PARTS & SERVICE NEWS

REF NO.	AT97078B
DATE	April 20, 2004

SUBJECT: REPAIR COUPLING ON TRANSMISSION AND HS150 TORQUE CONVERTER

PURPOSE: To introduce modification procedures to prevent slipping out of the press-fit inner cap inserted inside the coupling used for the transmission.

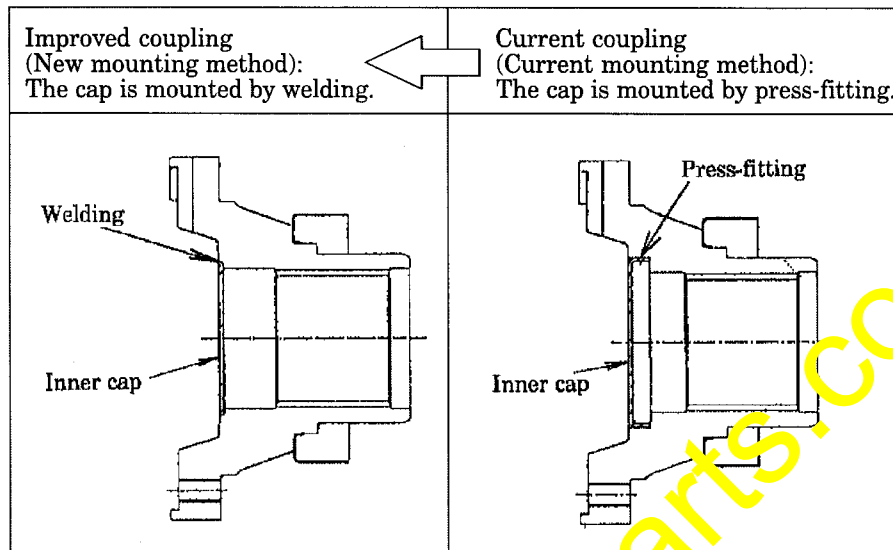
The press-fit inner cap inserted inside the coupling which is used for the transmission and for the torque converter of the HS150, as well as some of the other models listed on the Page 2 may slip out depending on the dimensional dispersions in the press-fitting section, causing oil leakage. To prevent this failure, implement the modification introduced in this **Parts & Service News**.

The mounting method of the inner cap for the coupling has been changed from the current press-fitting method to welding method to improve durability.

Replace the coupling with the improved part referring to the Shop Manual.
